AIR - INTRODUCE A SUPPORT BRACKET FOR THE FBC BUFFER AIR TUBE ASSEMBLY - CATEGORY CODE  
6 - MOD.ENG-75-0011

V2500-ENG-75-0011

Location of the FBC buffer air tube and the additional bracket at CP5799  
Fig.1

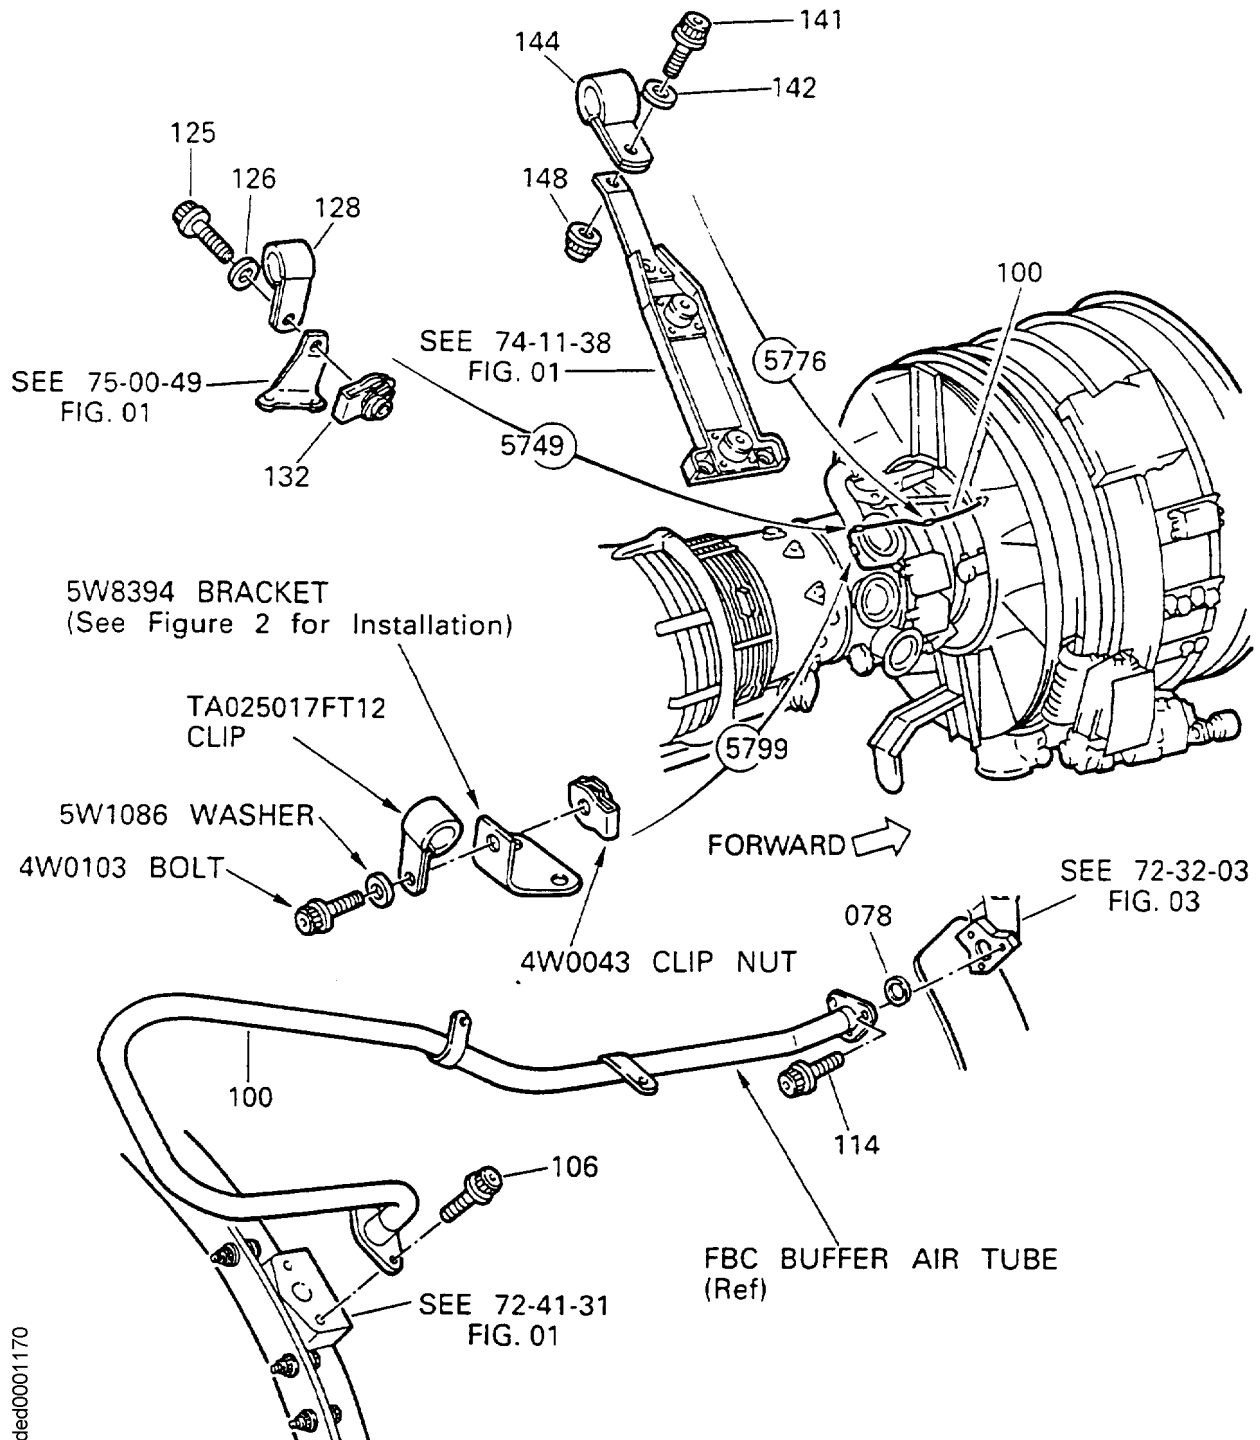
- (a) An additional clipping Bracket which is mounted on the Air Off-take Duct lower flange is introduced to hold the FBC Buffer Air Tube at an additional clipping position CP5799. (See Figures 1 and 2).

- (1) Install the additional 5W8394, Bracket, on the Air Off-take Duct lower flange when installing the Air Off-take Ducts to the HP Compressor Case by the approved procedures in the Engine Manual, 72-00-40, Installation, TASK 72-00-40-420-005. (Refer to Figure 2, and 1.K.(2)).
- (2) At additional CP5799, install the additional 4W0103, Bolt, 5W1086, Washer, TA025017FT12, Clip, and 4W0043, Clip Nut, to the additional 5W8394, Bracket, and the FBC Buffer Air Tube, when installing the Tubes by the approved procedures in the Engine Manual, 72-00-40, Installation, TASK 72-00-40-420-006. Torque the Bolt to 36 - 45 lbfin. (4,00 - 5,00 Nm) at CP5799. (Refer to Figure 1, 1.K.(2), and 1.K.(3)).
